*Energy Harbor Nuclear Corp
Perry Nuclear Power Plant
10 Center Road
Perry, Ohio 44081*

Perry Nuclear Power Plant
Docket No. 50-440, License No. NPF-58
EMERGENCY PLAN FOR PERRY NUCLEAR POWER PLANT DOCKET No. 50-440

Pursuant to 10 CFR 50.4, enclosed is a summary of changes for the Perry Nuclear Power Plant (PNPP) Emergency Plan Revision 59.

Perry Nuclear Power Plant EP 0000 Revision 59 Change Summary

FIGURE 6-1 - EMERGENCY NOTIFICATION

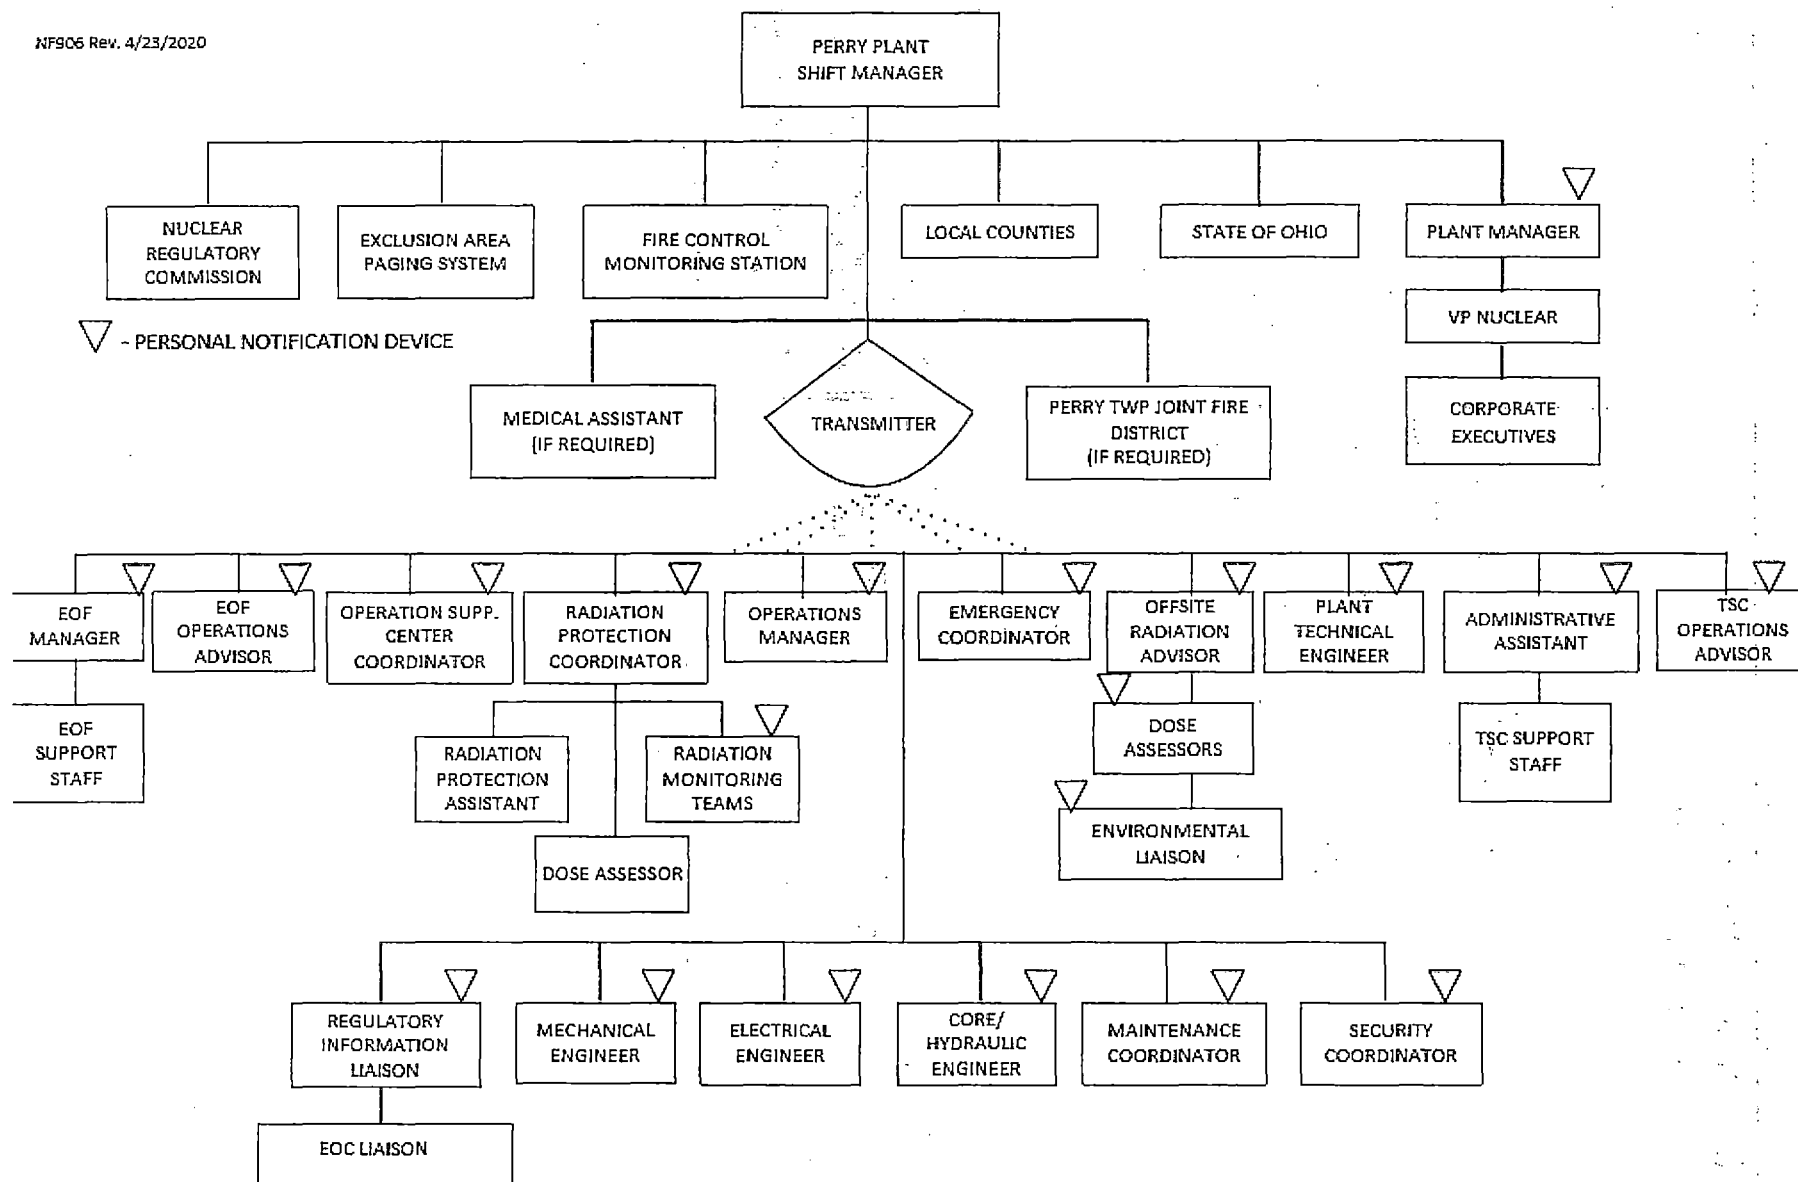
16. Table 5-1 FirstEnergy changed to PNPP
 17. Figure 6-1 Changed removed FirstEnergy
 18. Section 6.2.3.2 Removed FirstEnergy.
 19. Figure 7-2 Changed FirstEnergy to Engineering, Communicator's and Dose Assessor's

FIGURE 6-3 - PROTECTIVE ACTION FLOW CHART

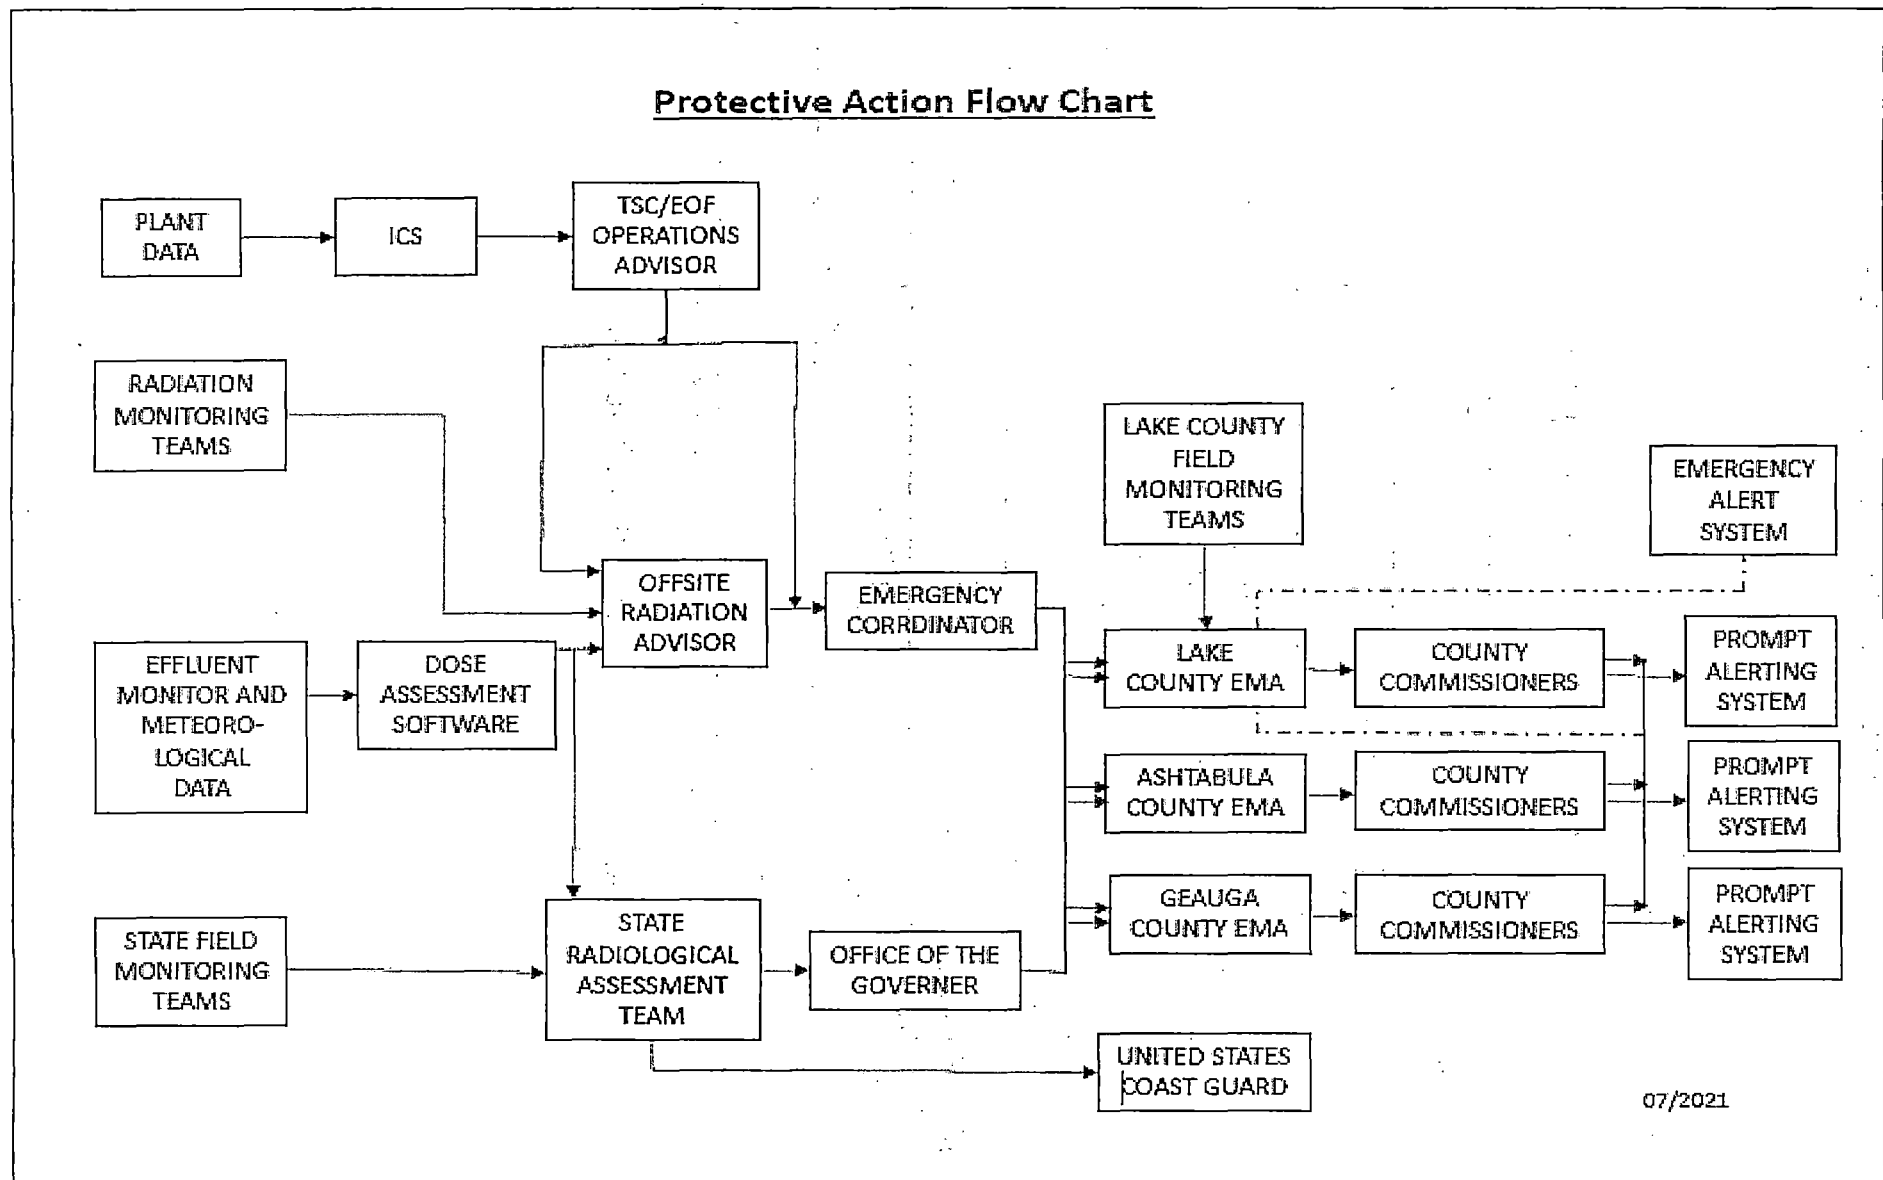
PY-2019-014-00 was a previous 10 CFR 50.54 (q) completed to change the dose assessment software. This figure was changed to remove the name MIDAS which was the previous dose assessment software.

27. Appendix D FENOC Quality Assurance Program Manual changed to remove FENOC.
 28. Figure 6-3 MIDAS replaced with dose assessment software.
 29. Section 8.8.3 NOBP-LP-2001, FENOC Self Assessment/Benchmarking title changed to reflect new title without FENOC

FIGURE 9-1 - RECOVERY ORGANIZATION

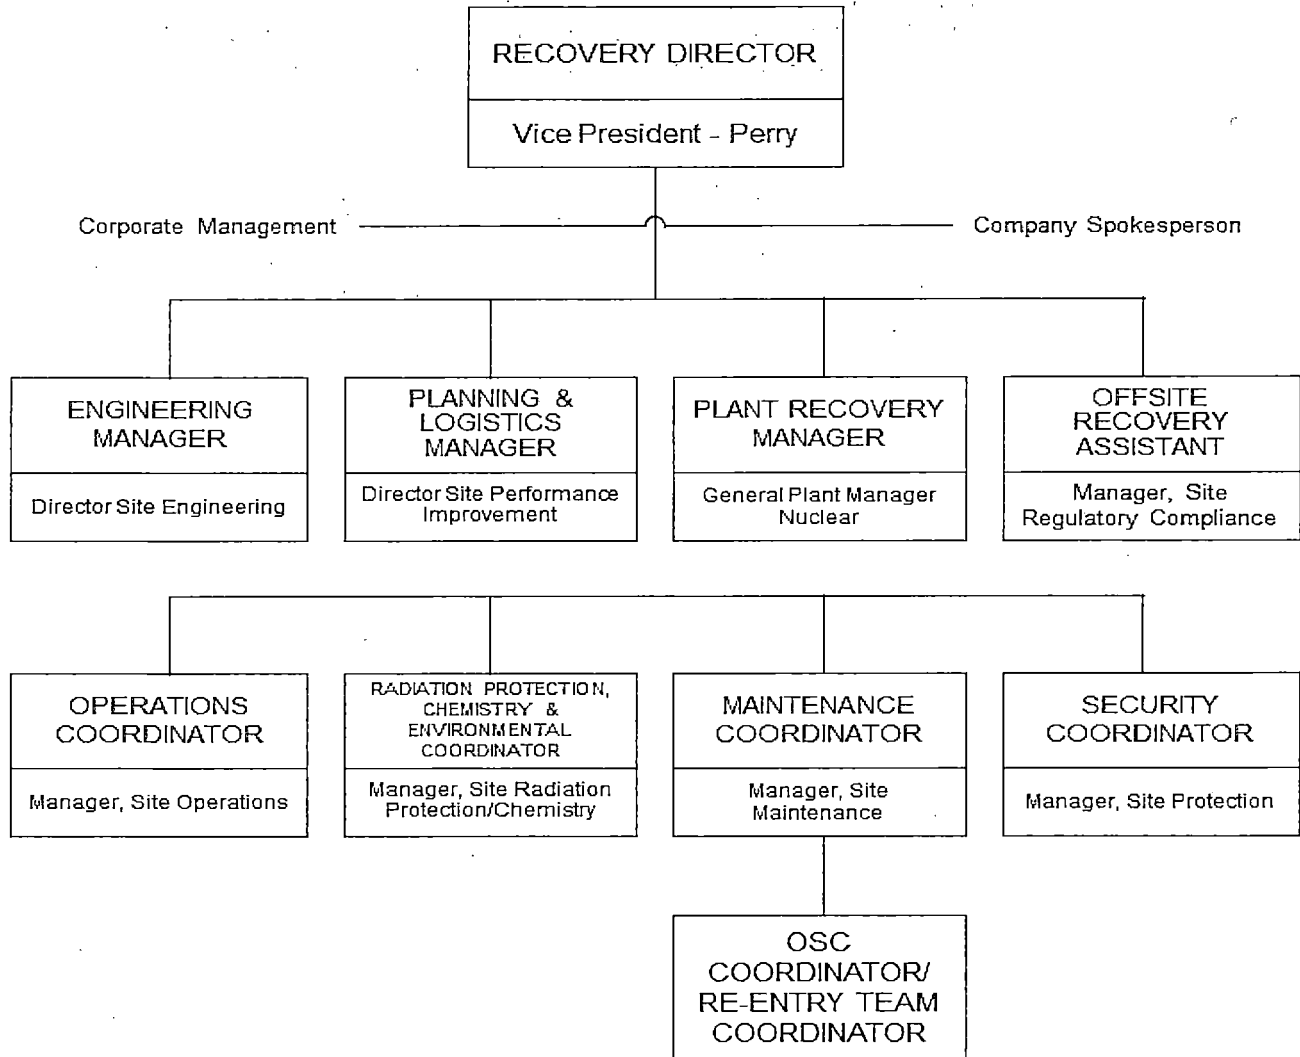
The Chemistry and Radiation Protection Manager positions were merged into one position. The name of the position was merged to account for one position rather than two.

30. Section 8.8 NOBP-LP-2001 title change.
 31. Figure 9-1 updated to combine the RP & chemistry manger positions
